REVISION

RE: Revised Tree Inventory and Retention Plan - 19023 37th Ave. NE. Lake Forest Park, WA.

This revised report is provided to address the requirements of the City of Lake Forest Park for tree inventories and retention on developing properties. The requirements for this study and report are specified in LFPMC 16.14.040.C.2.b and c. This revised report also addresses the comments issued in the comment letter dated September 26, 2019. See Section 4 for the comments and the responses.

TREE INVENTORY MAP
19013 37TH AVE NE
SELECT HOMES

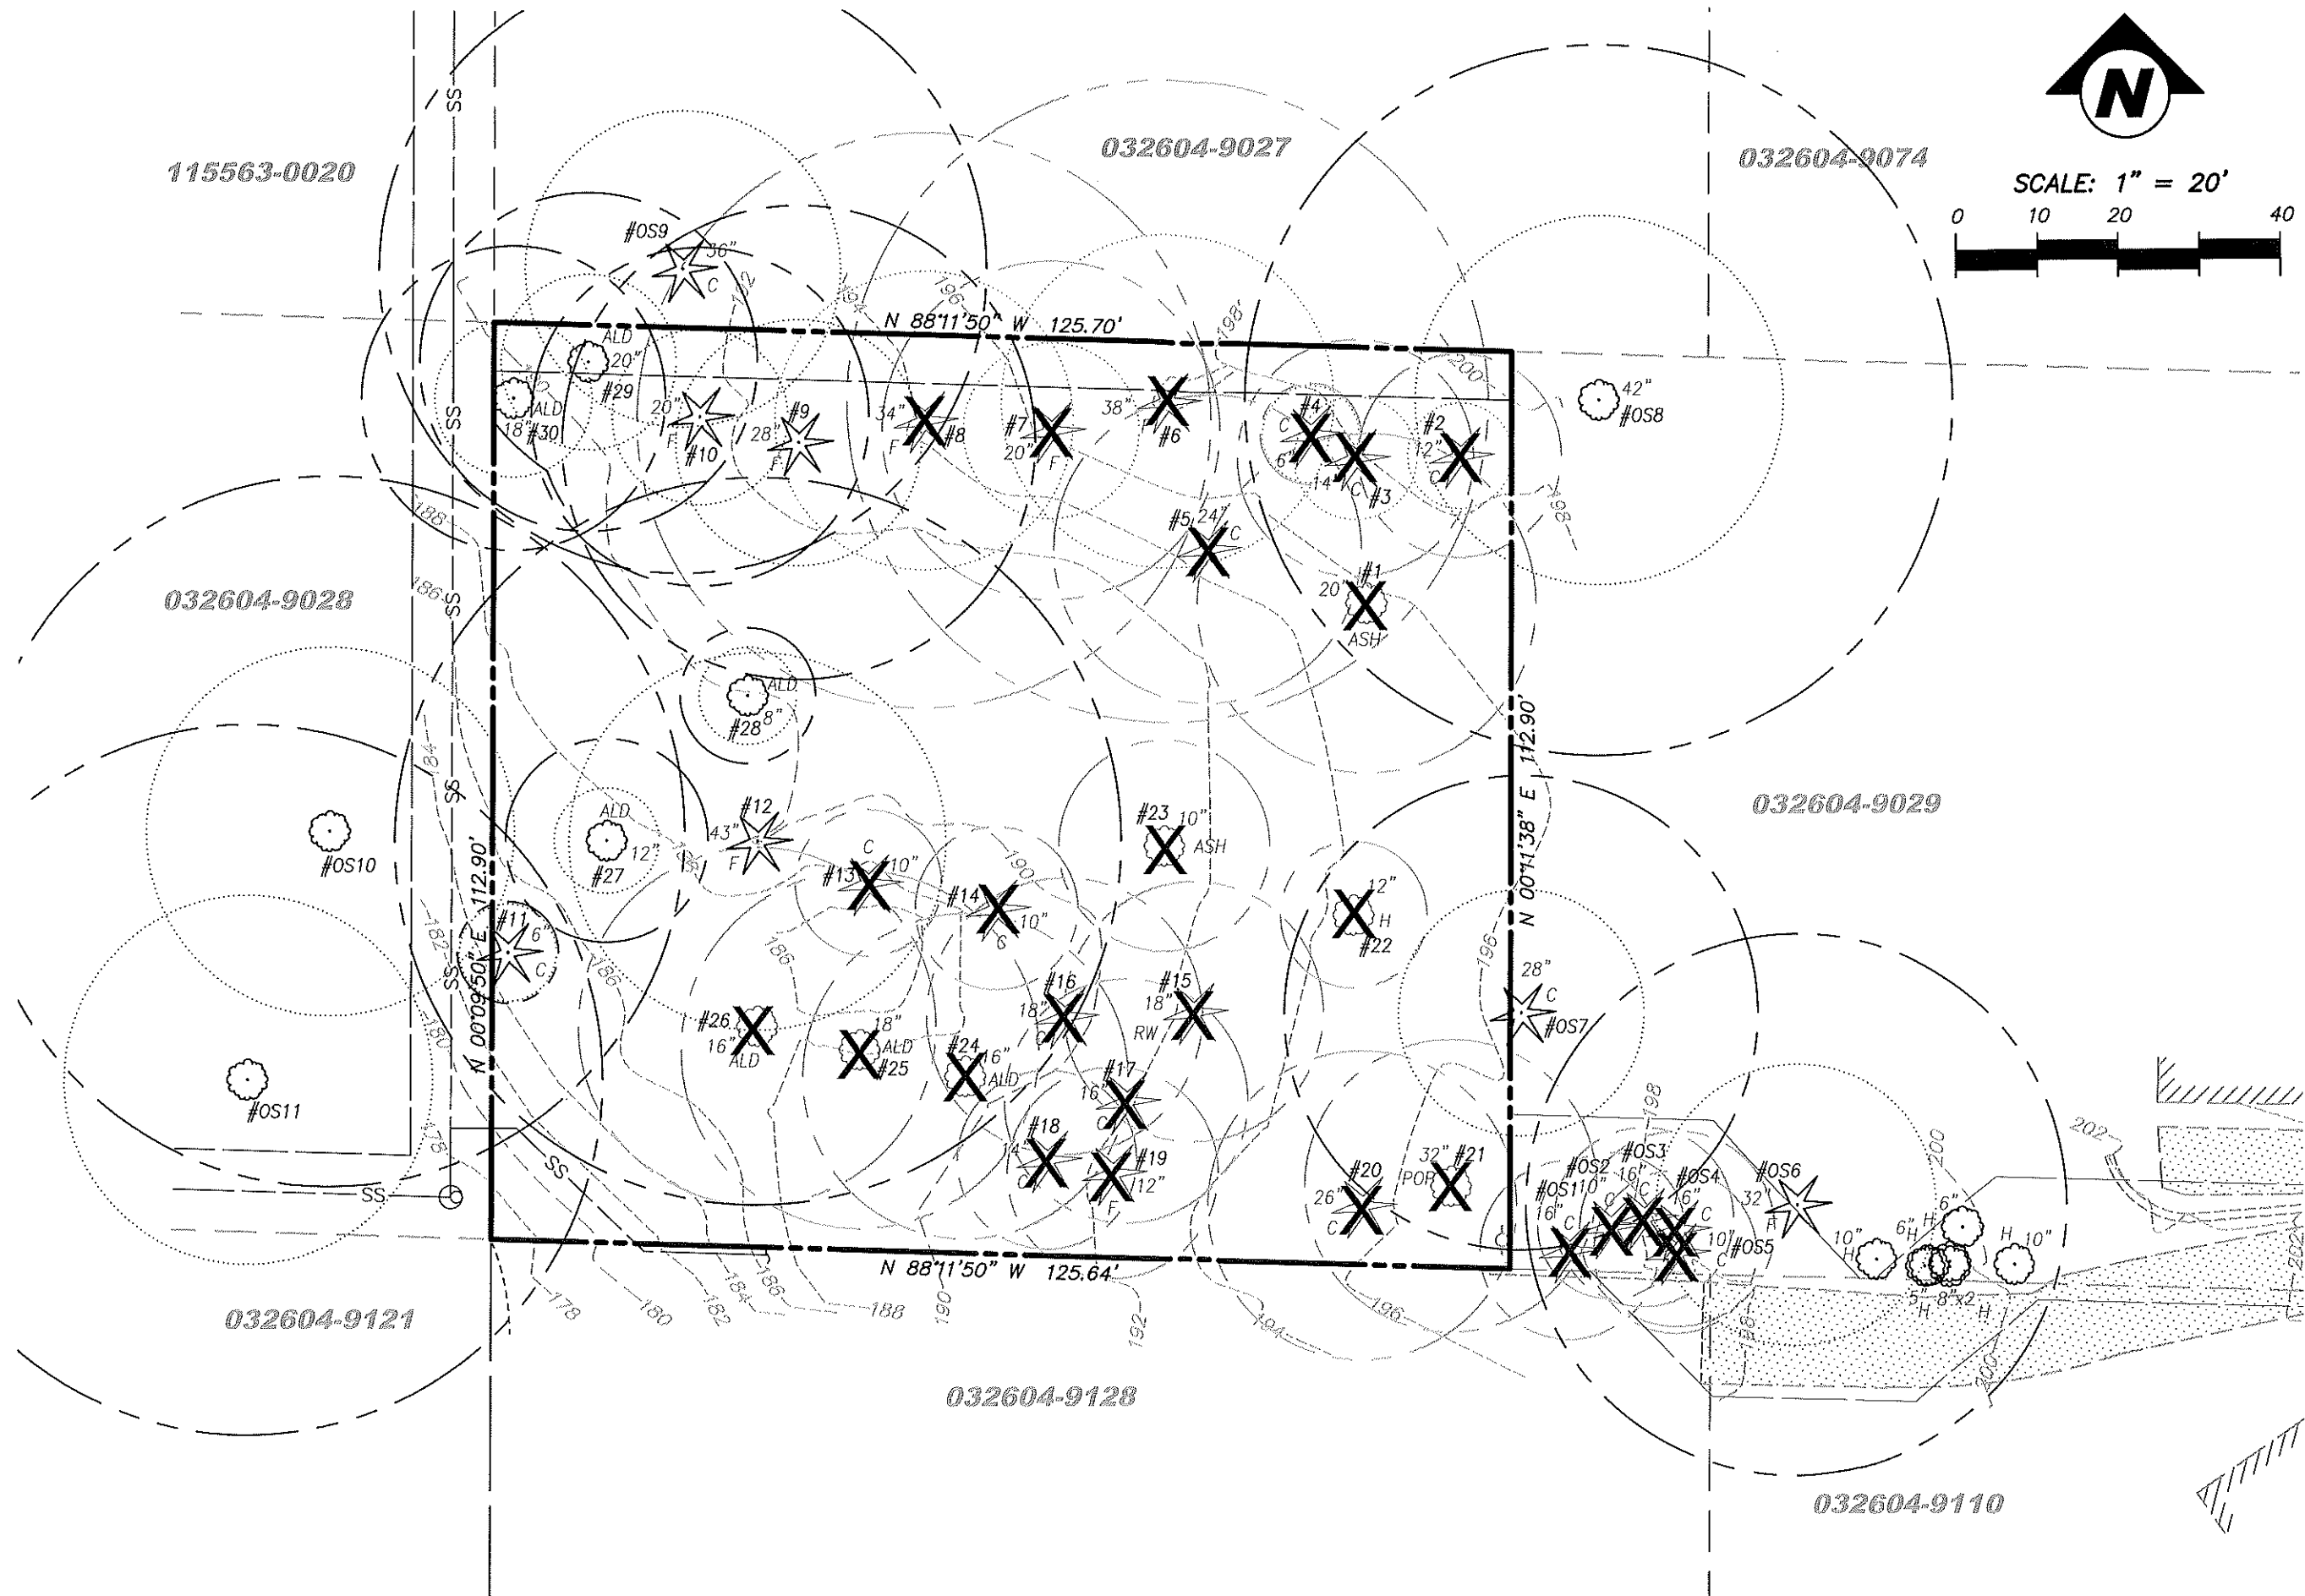
2. Tree Inventory Table:

- a. There are several significant trees on the property as well as off-site trees that will be impacted by the development that are not included in the tree inventory. Please update inventory table to include these trees.

- c. Please include the critical root zone (CRZ) and interior critical root zone (ICRZ) for all trees.

Two trees located off-site to the east, north and west have been added to the table. I did not see any other trees that will be impacted by the proposed development.

The CRZ and ICRZ for each tree has been added to the table.

TREE REPLACEMENT PLAN
19013 37TH AVE NE
SELECT HOMES

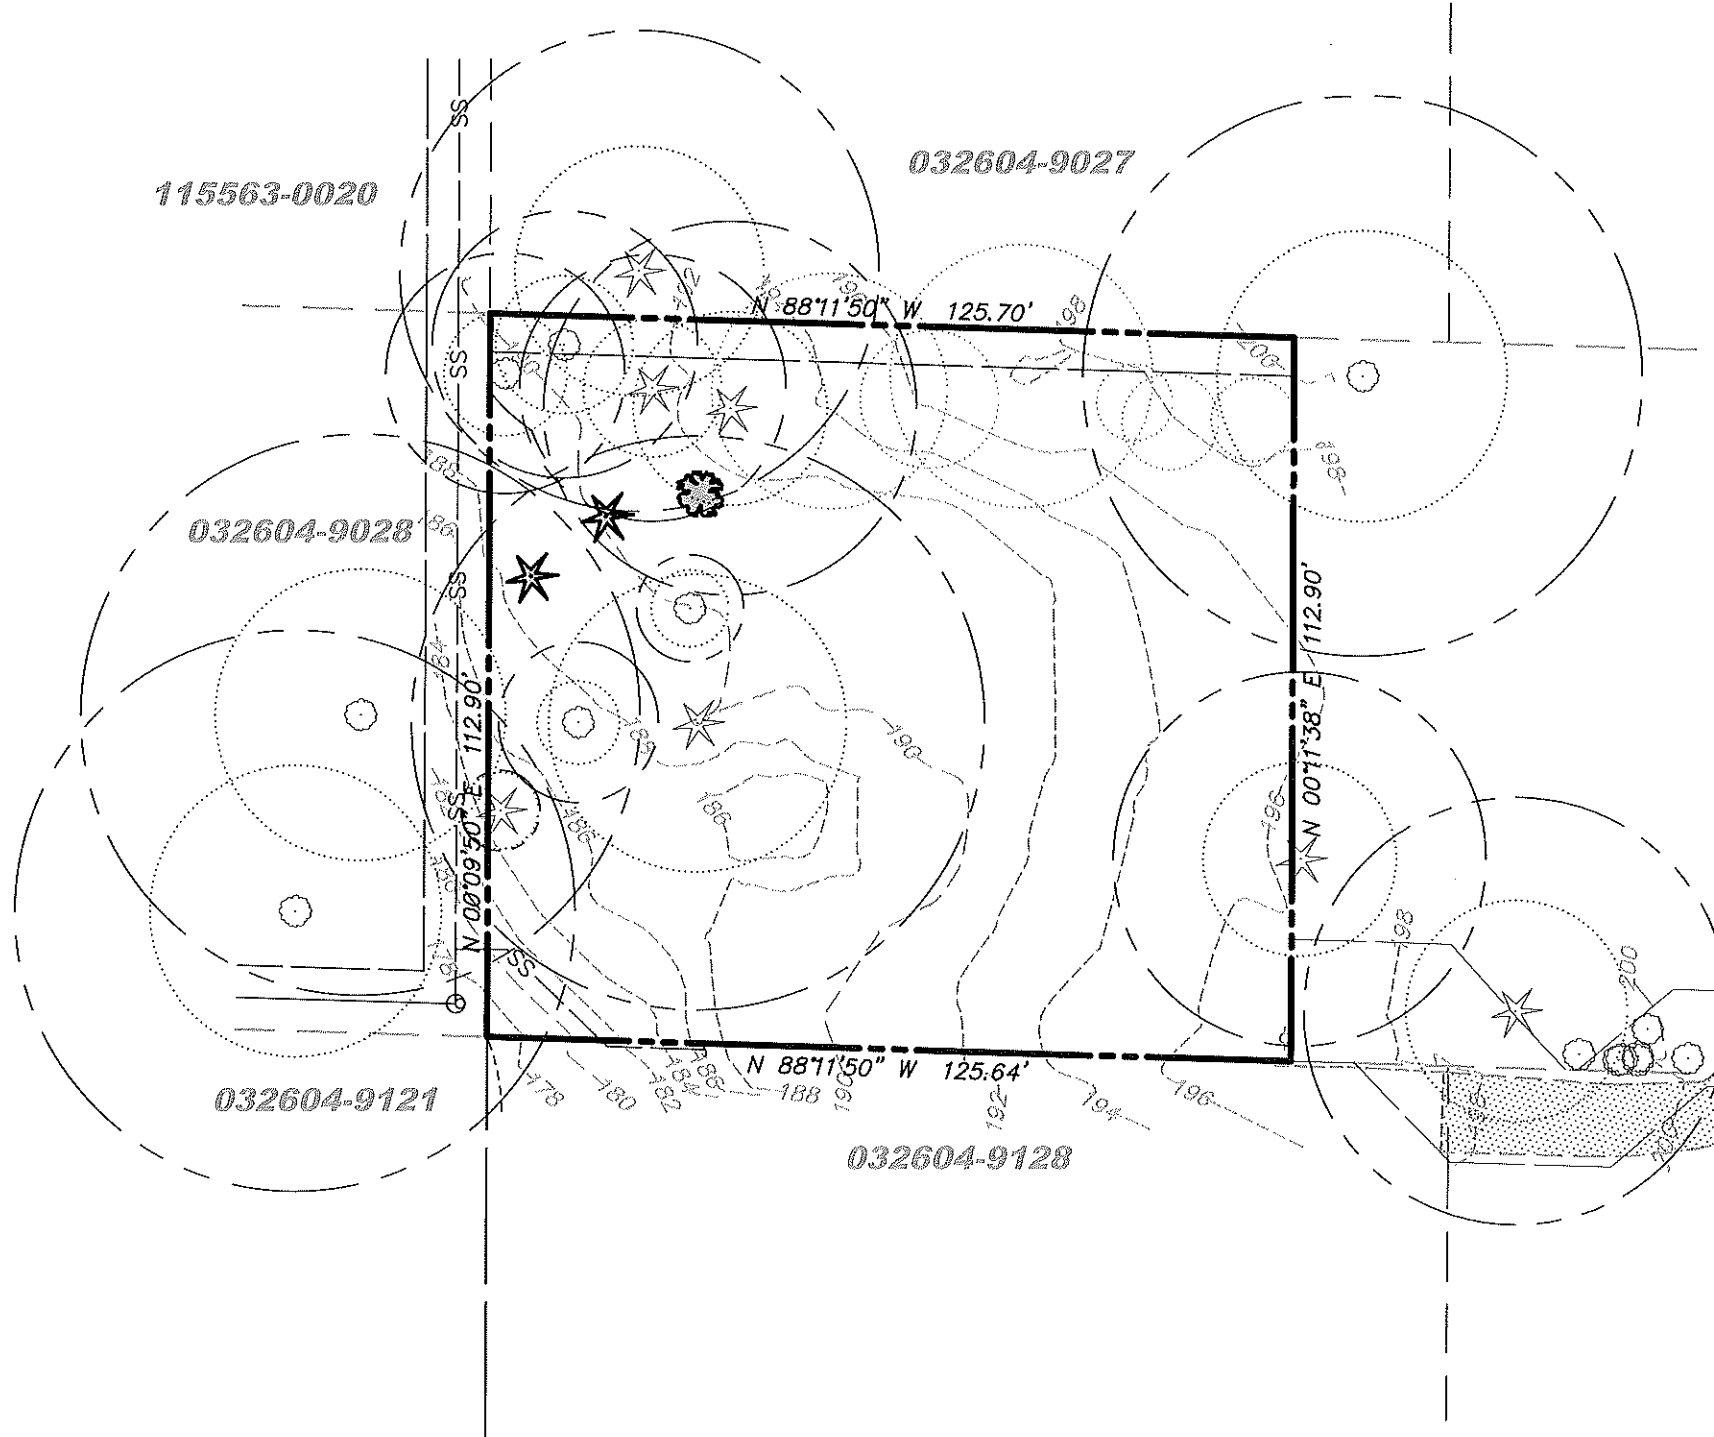
- c. If replacement trees will be needed to meet the lot's 39% canopy coverage goal, please provide a replanting plan with the species of trees to be planted and location. See LFPMC 16.14.090 for more details on replacement tree plans.

Per the recommended replacement trees, two Douglas fir and one western red cedar, at maturity, the proposed replacement trees will provide a minimum of 962 square feet of canopy area each for a total canopy area coverage of 2,886 and a total canopy coverage of retained and replaced trees of 10,482 s.f., satisfying the required 39% coverage.
